**SAN ANTONIO WATER SYSTEM
HIGHLAND ESTATES, UNIT 1 P.U.D. MONTANA PASS FLOATING GROUND
STORAGE TANK PROJECT**

**SAWS JOB NUMBER 15-1177
SOLICITATION NO. CO-00092**

**ADDENDUM NO. 5
October 13, 2016**

PIPE SAFETY RAILING

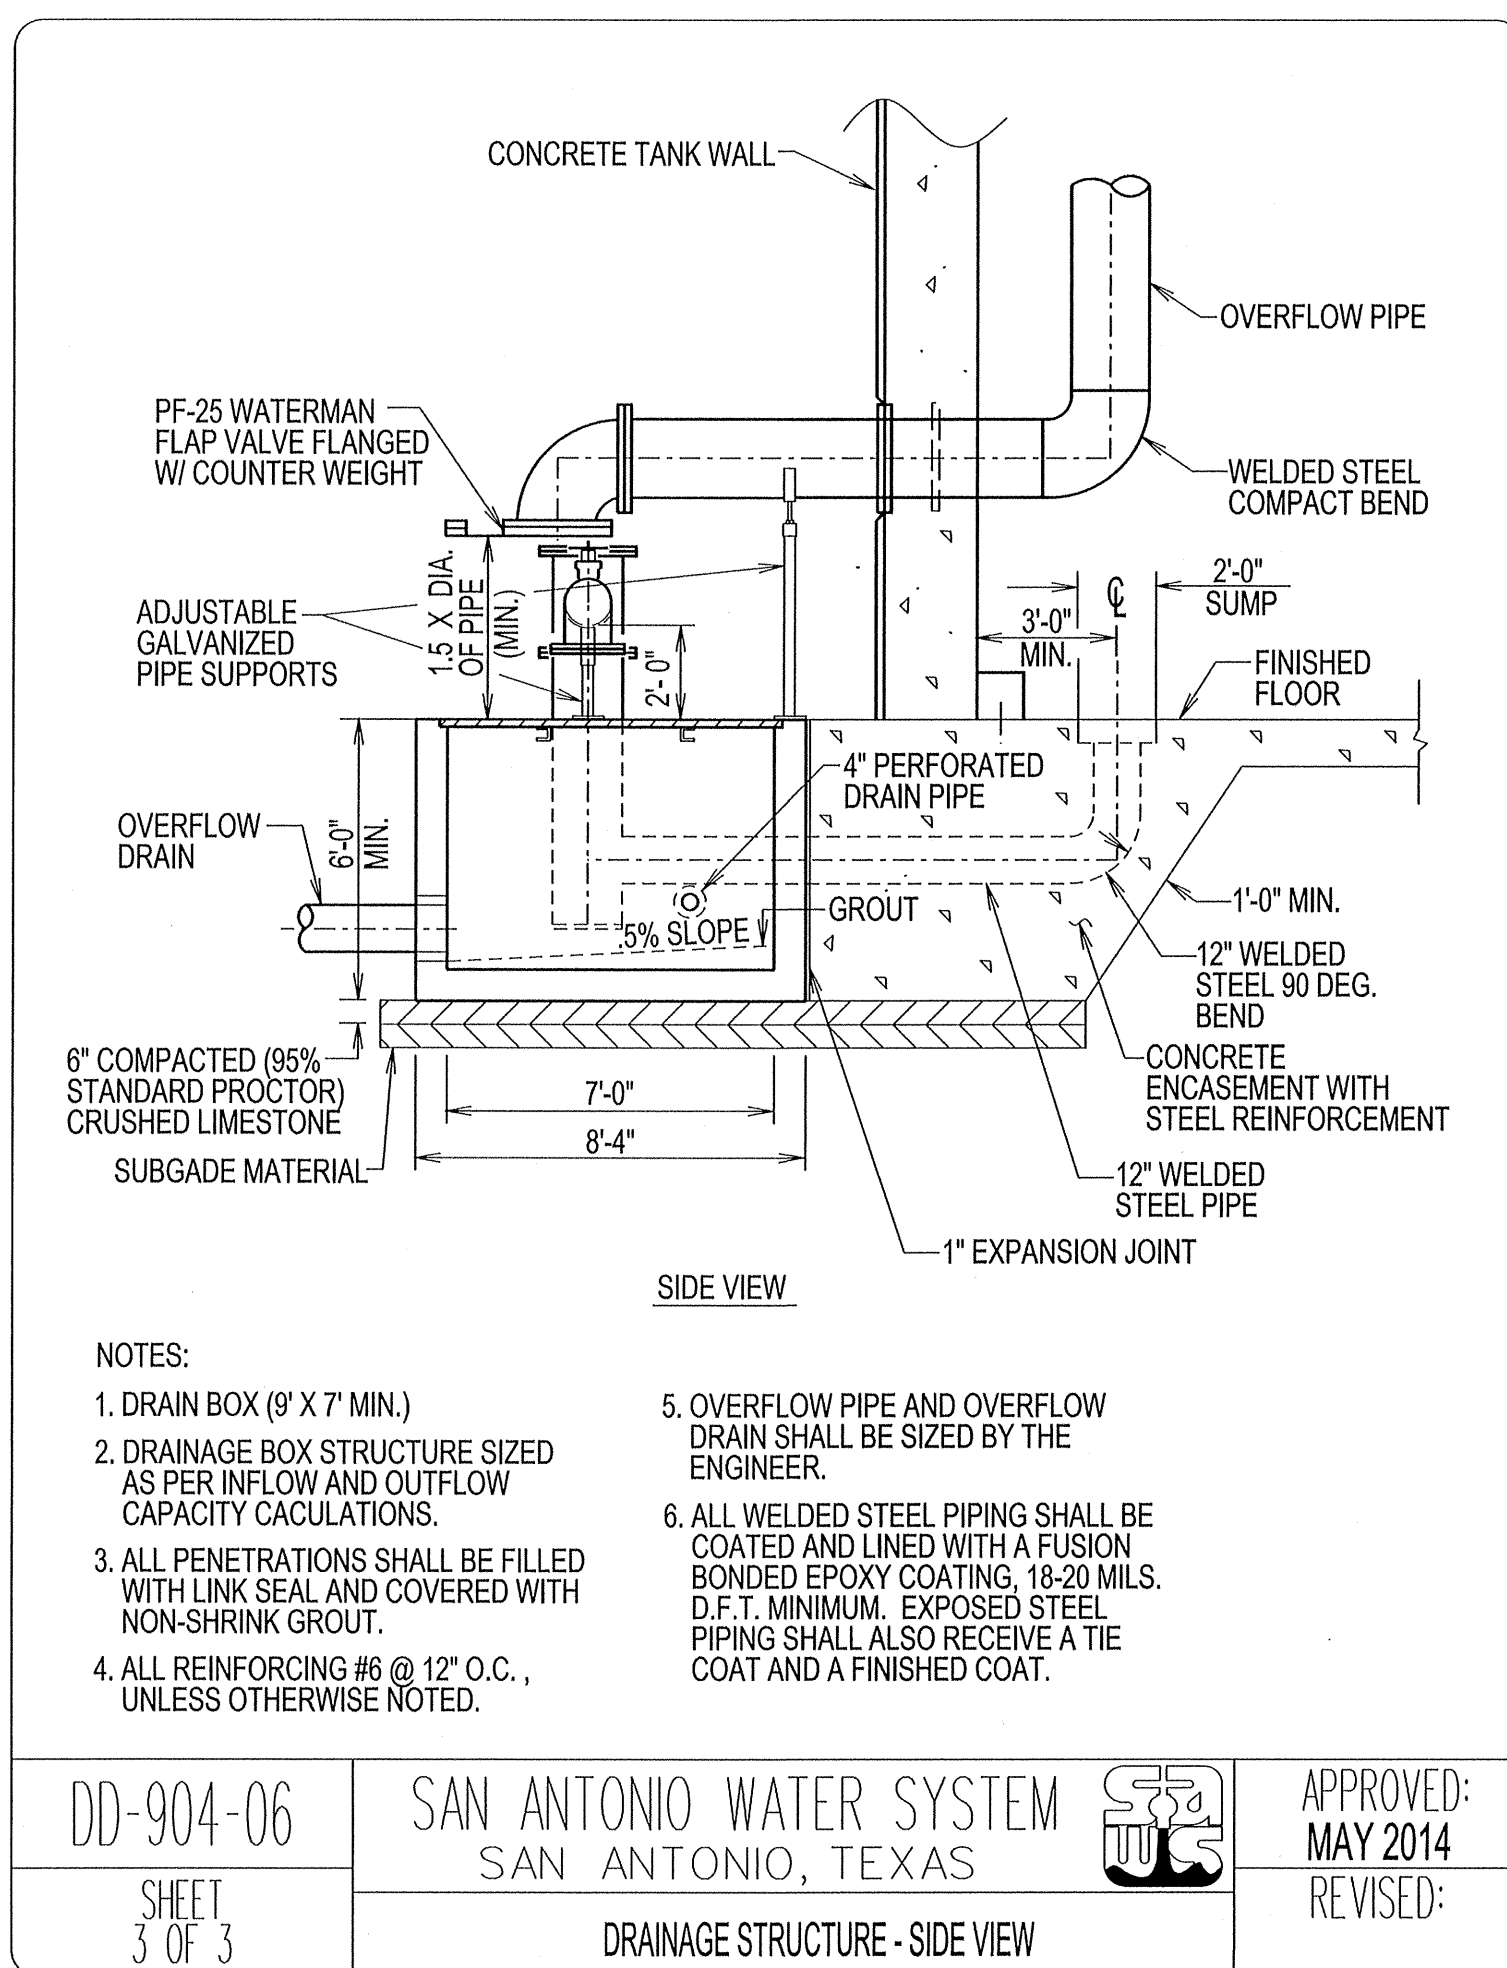
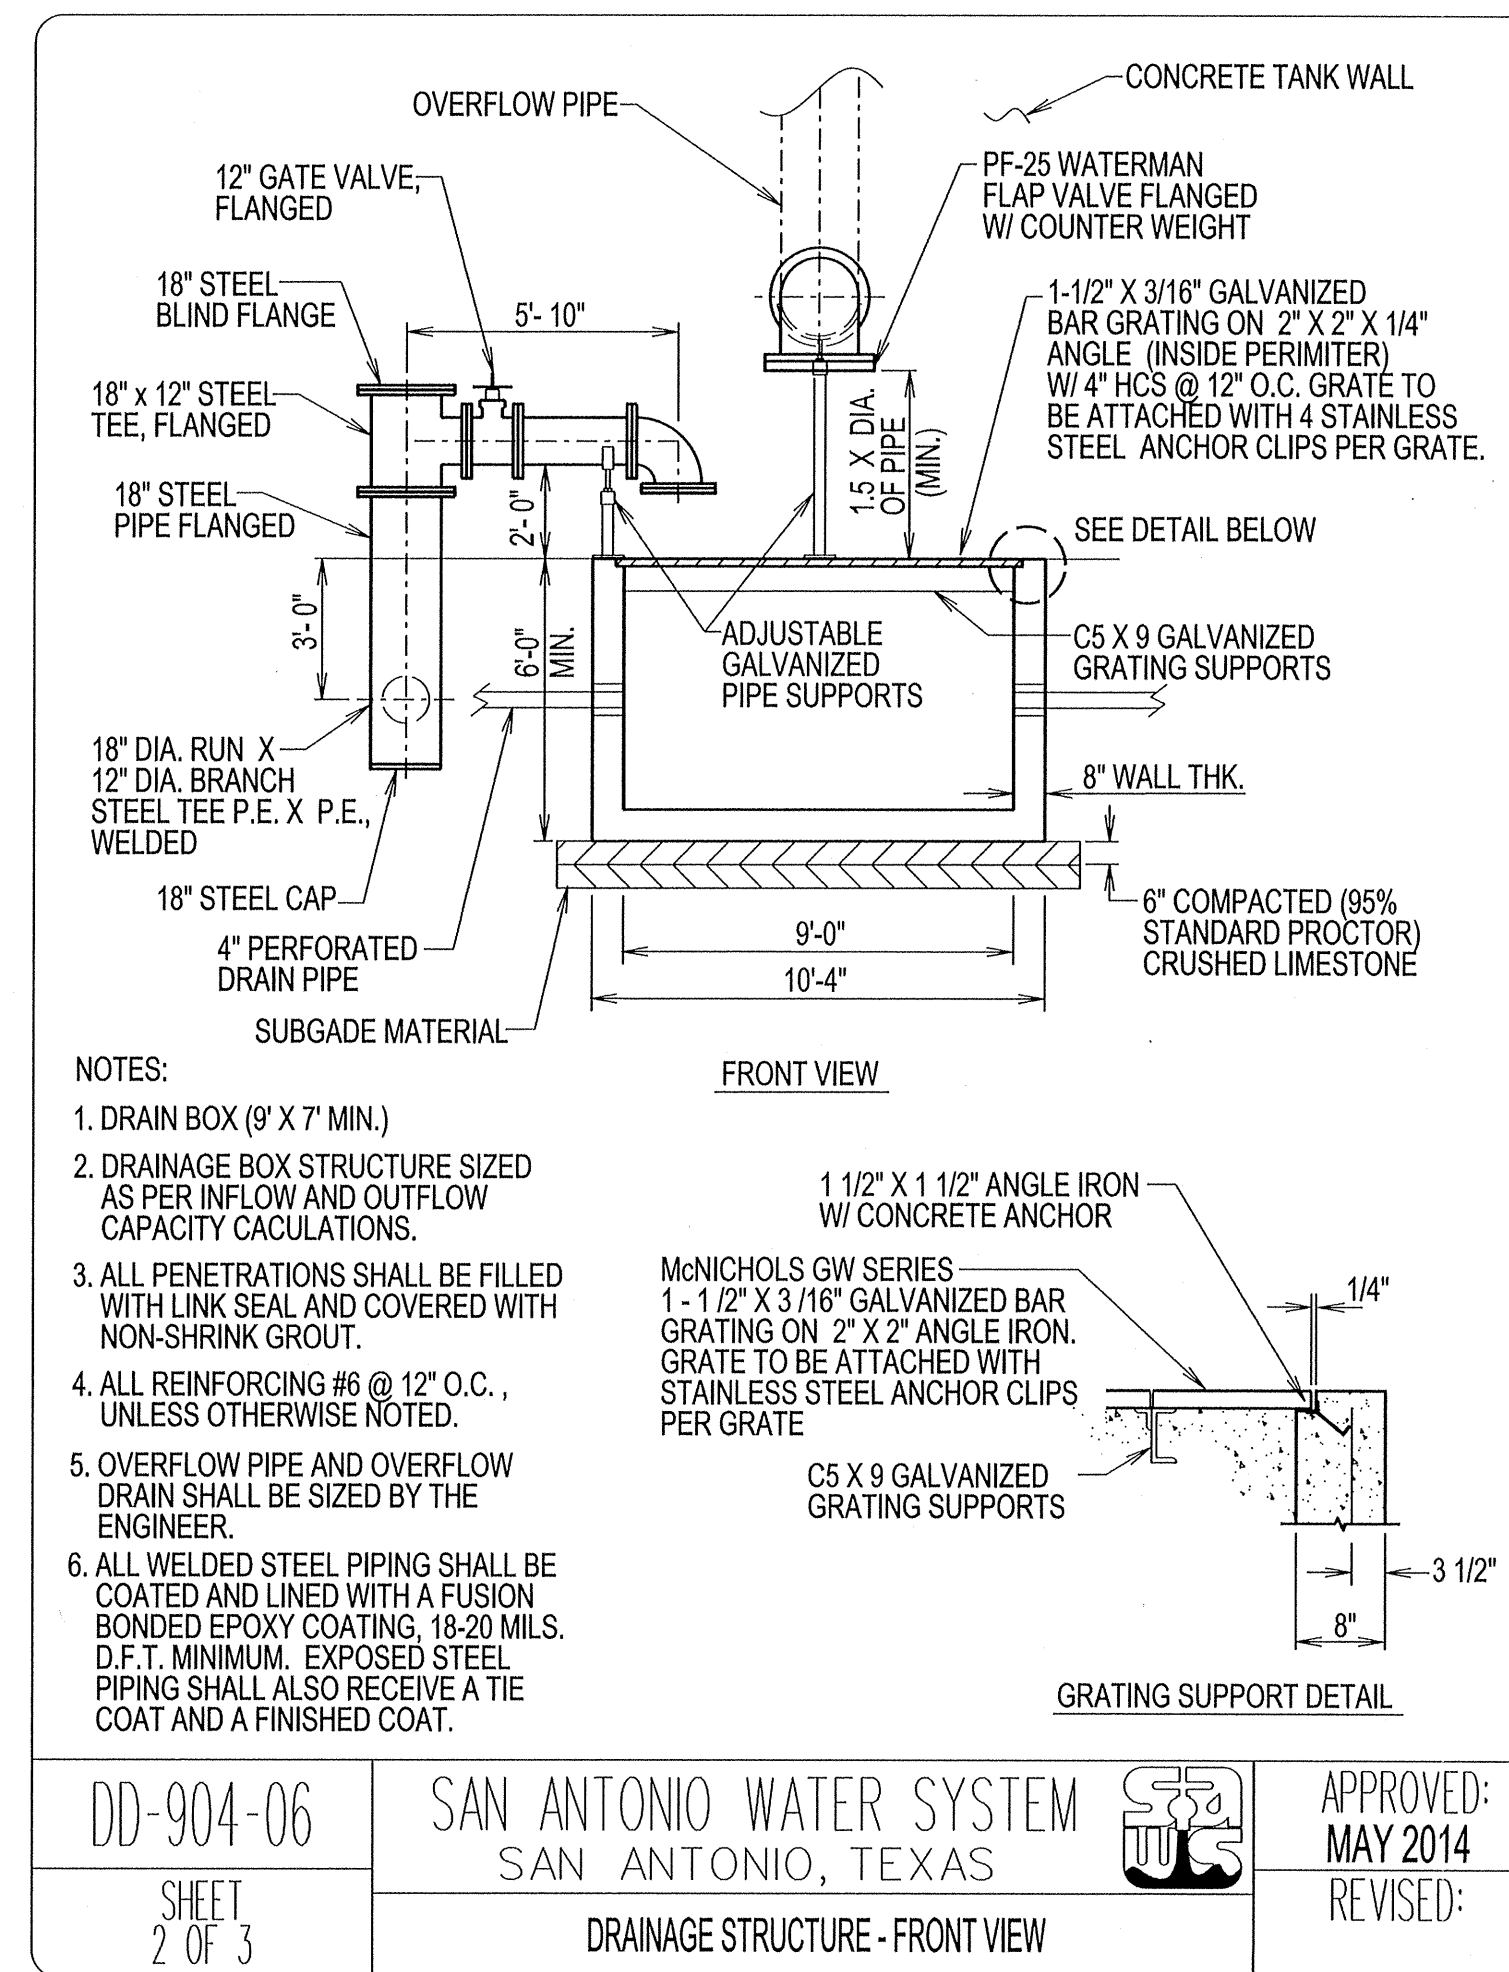
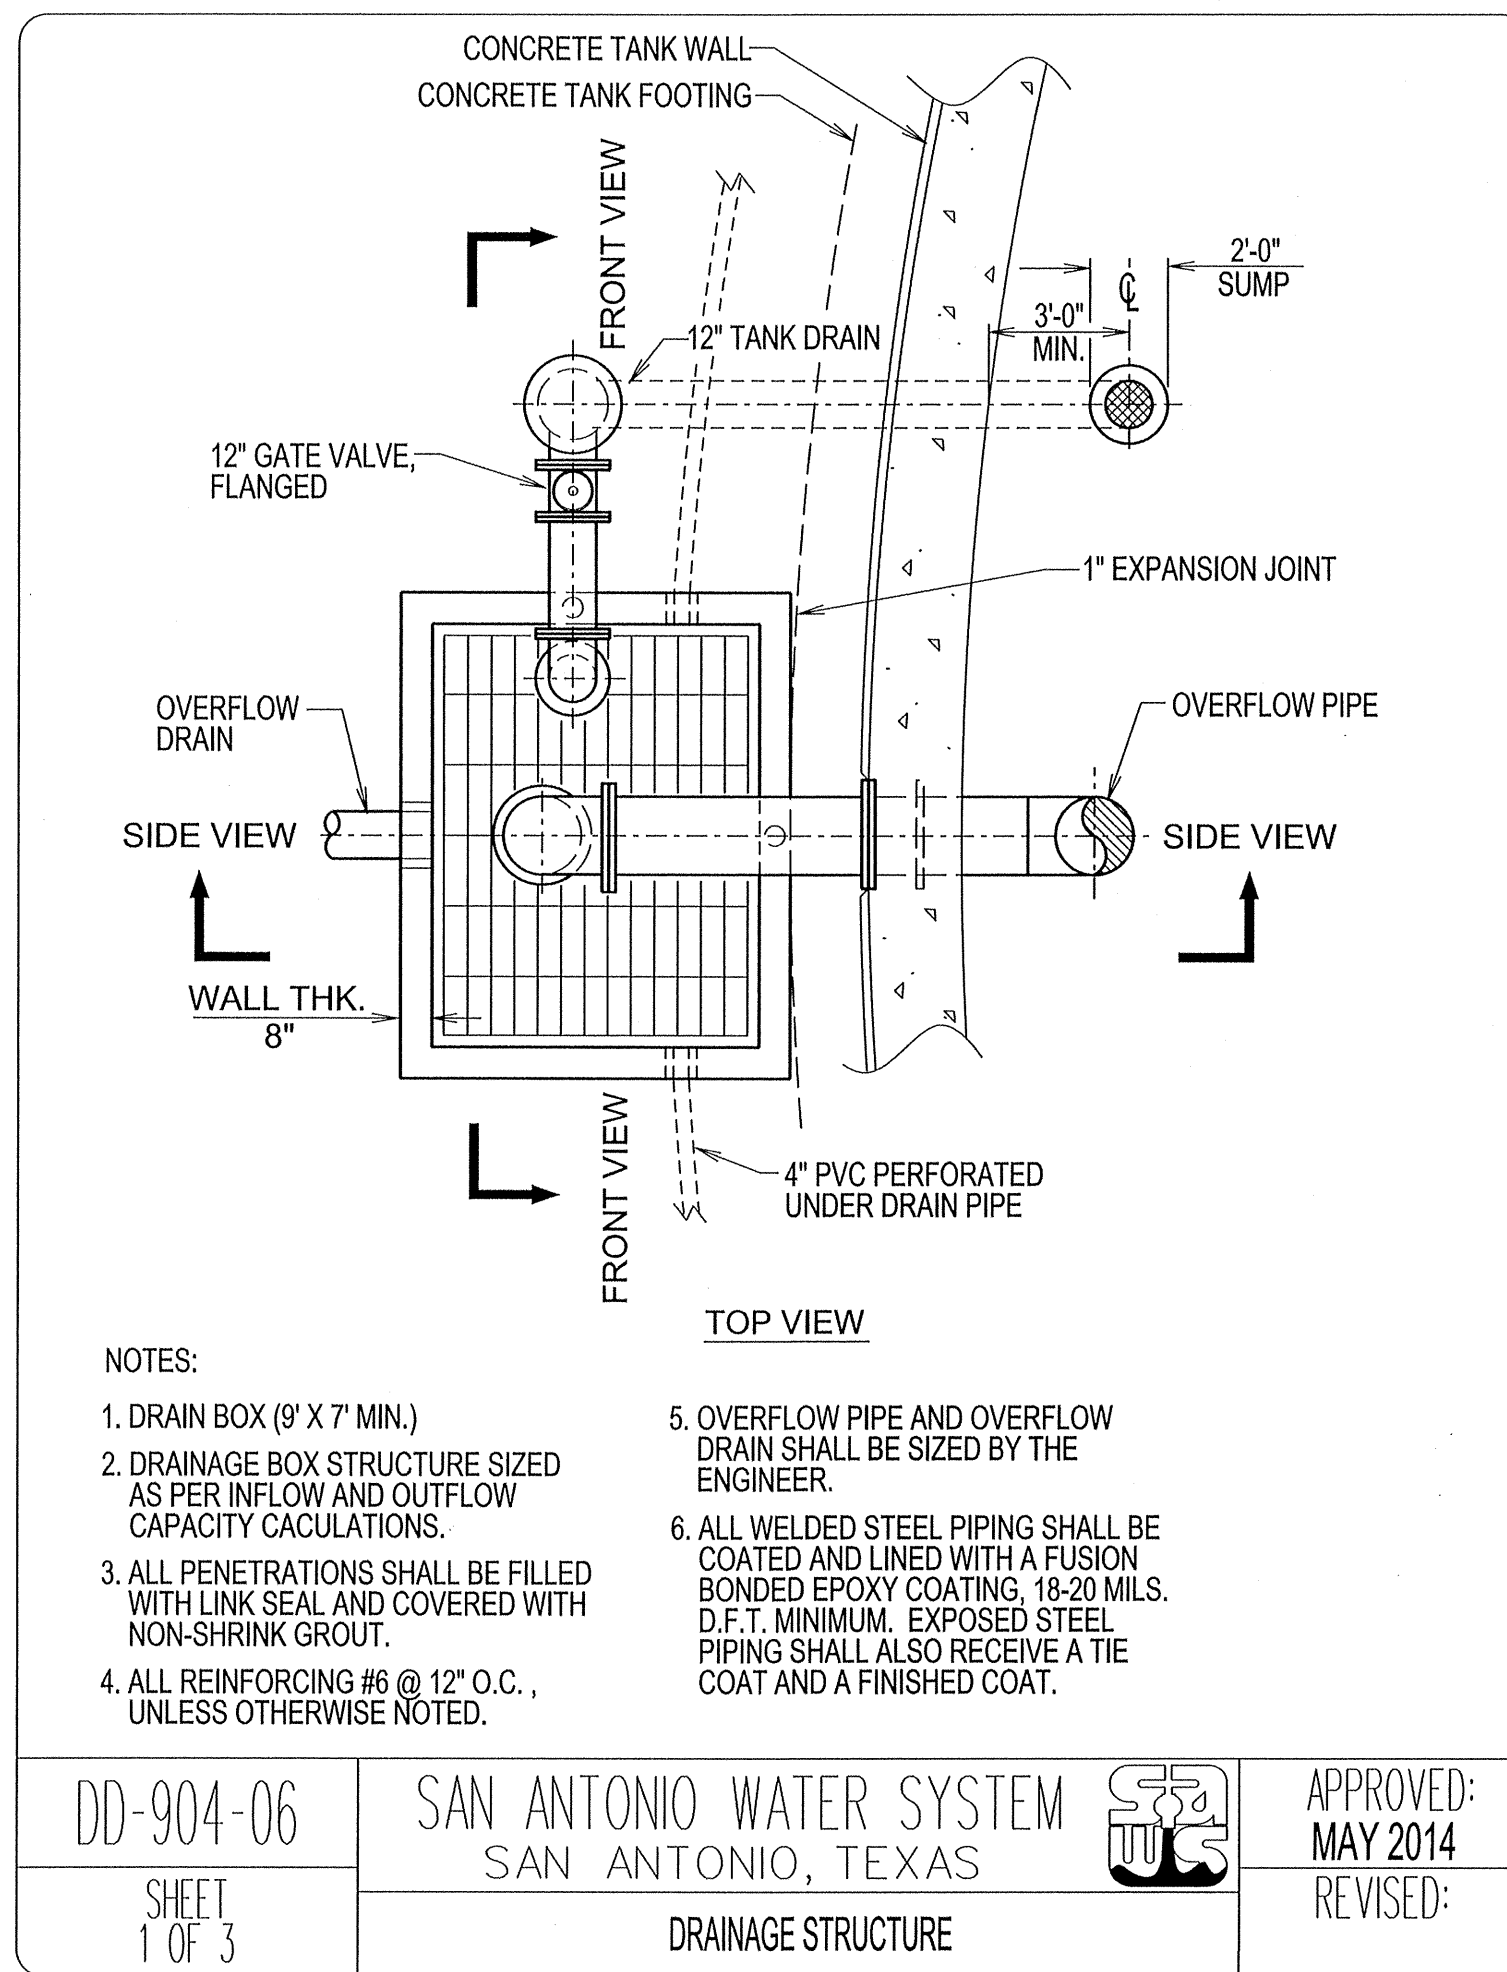
8. Sheet T-6, indicates all of the pipes shall have 3’-0” min. cover from the tank finish floor elevation. Sheets C-6.1 and C-6.2 indicate the pipes shall have 5’-0” minimum cover from finish grade. Please confirm the bury depth or centerline elevation for all tank piping.
Minimum cover on pipes shall be 5’. Refer to revised Sheet T-6R1 attached as part of this addendum.

9. Sheet T-2, please confirm the handrail material for the tank dome.
Handrail material is 1½” Schedule 40 stainless steel 316L pipe. Reference Pipe Safety Railing detail on Sheet T6R1.
